Addendum No. 1

East Pearl Street Parking Lot Improvements

For City of Jerseyville
Jersey County, Illinois

H&A File No. 140-337
March 11, 2021

SHEET NO.
9

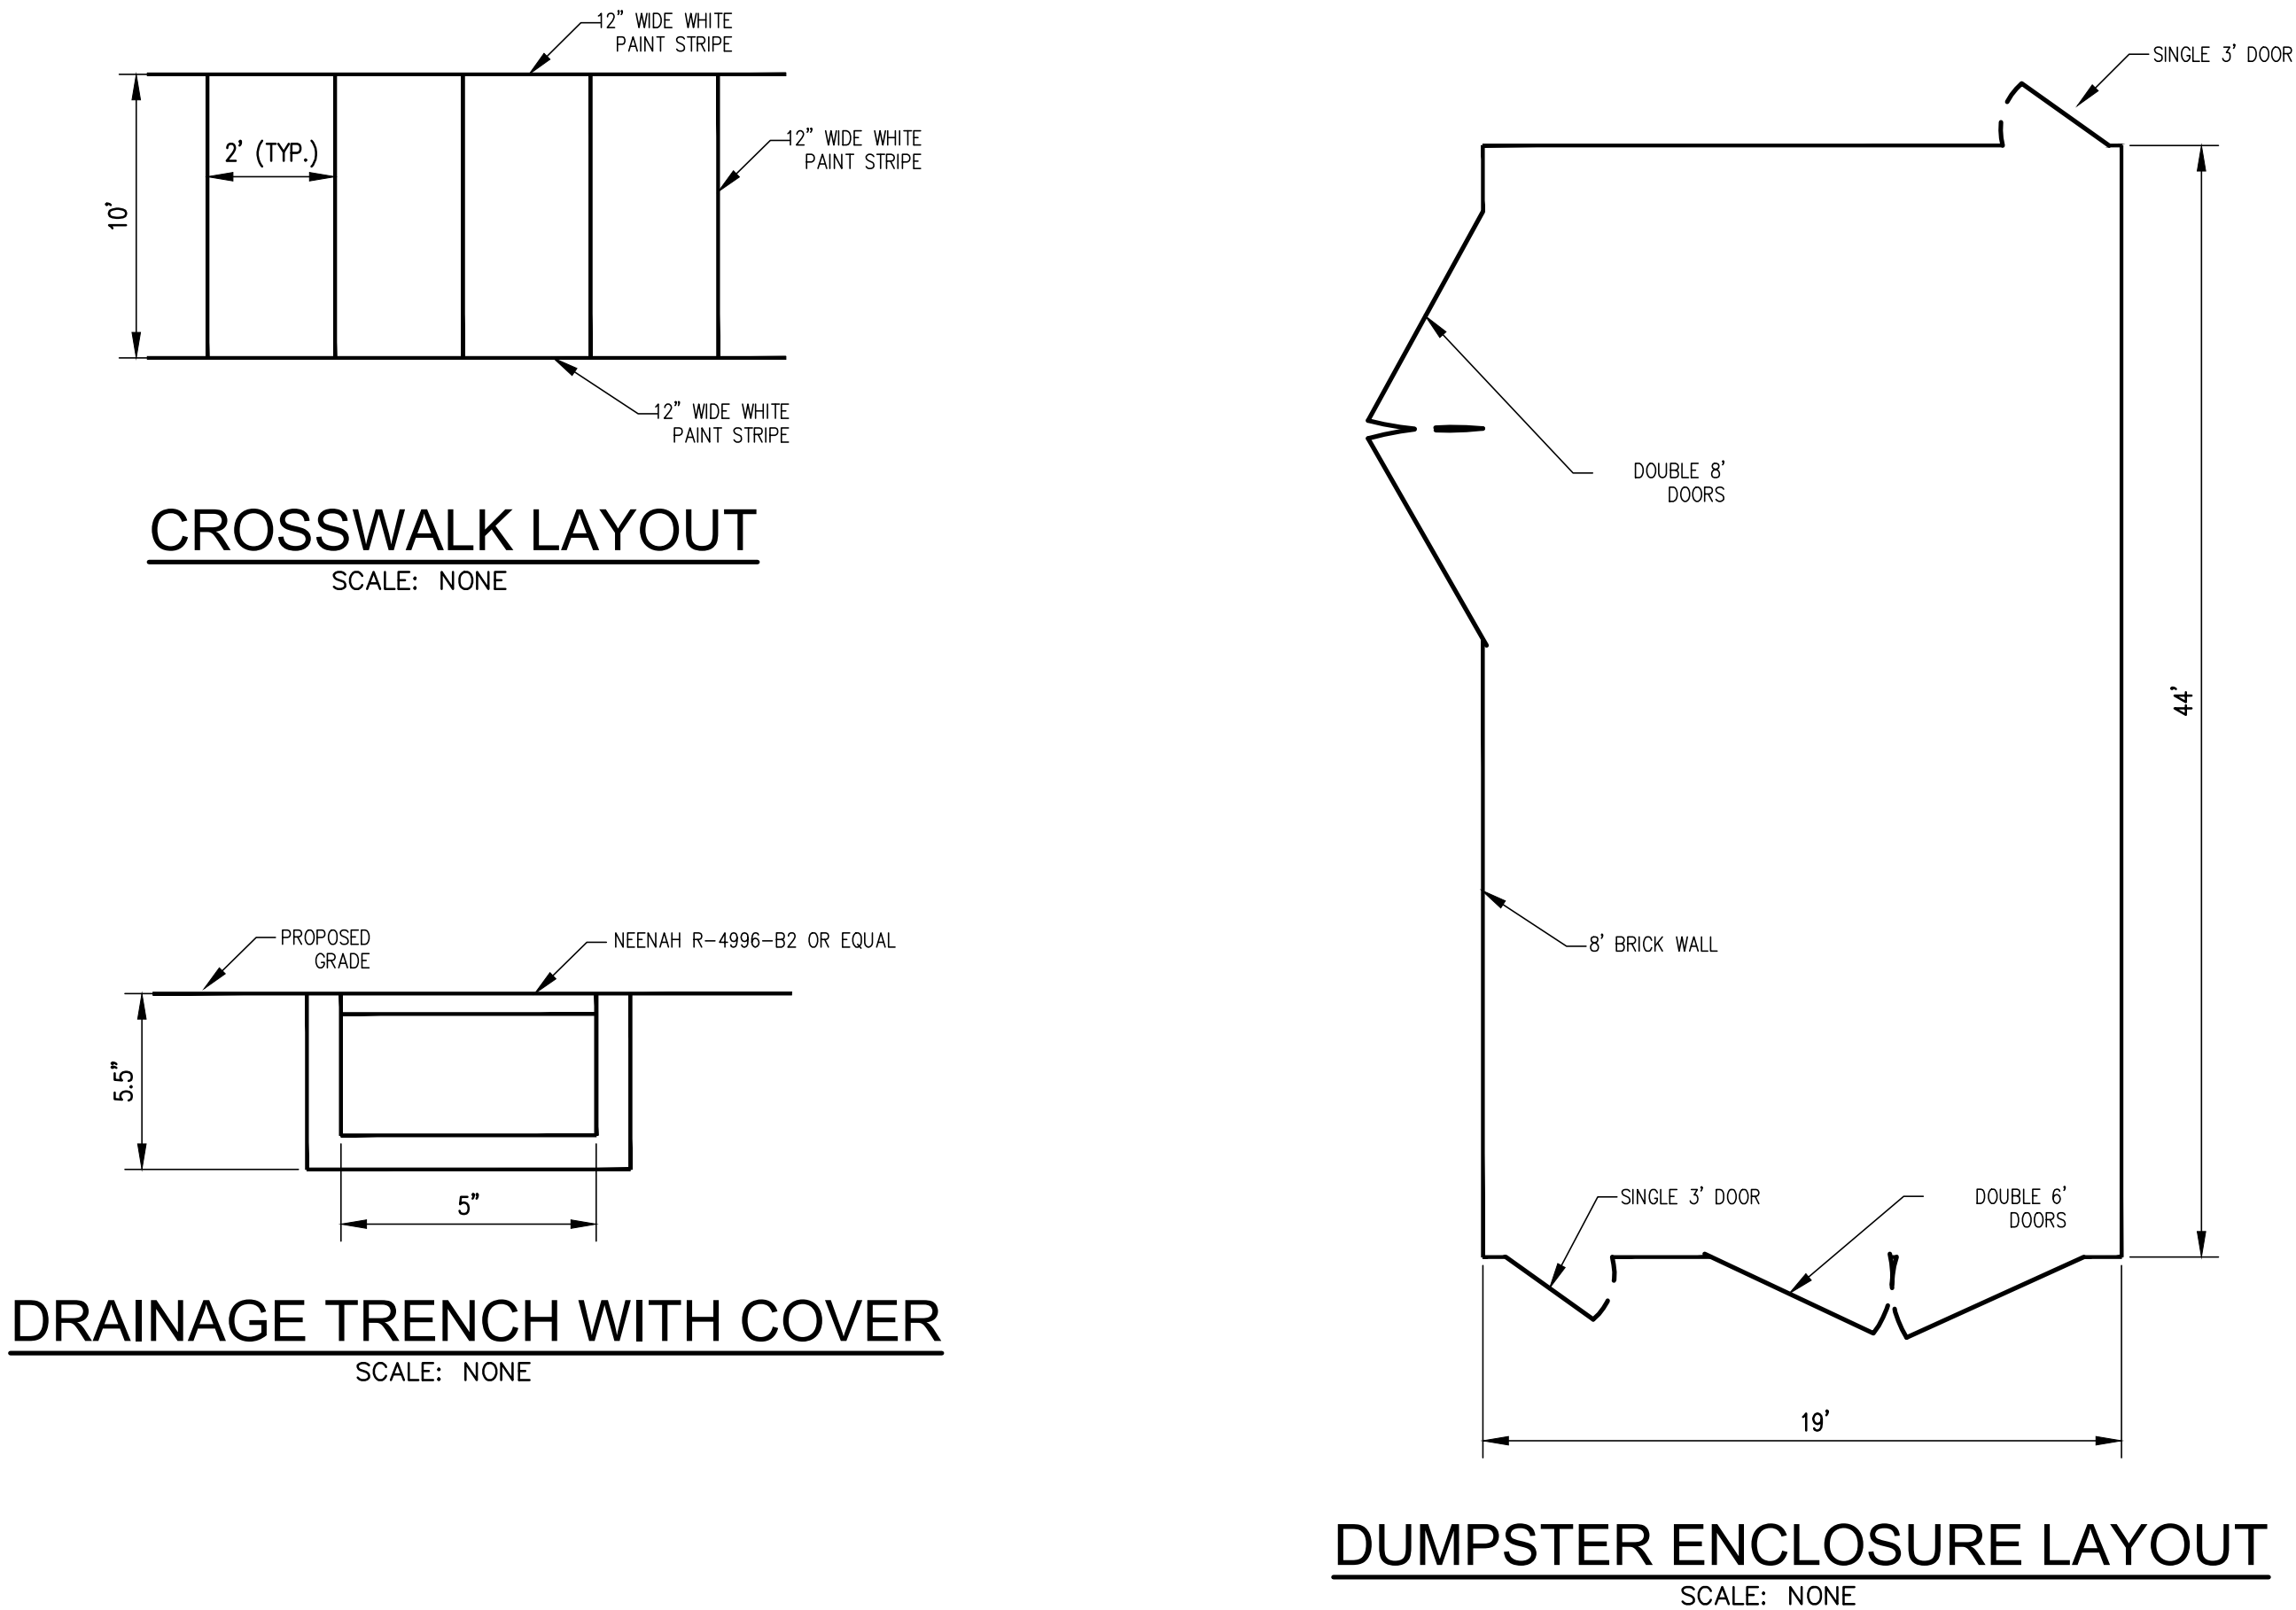
Sheet 9: Added details for dumpster enclosure and drainage trench with cover
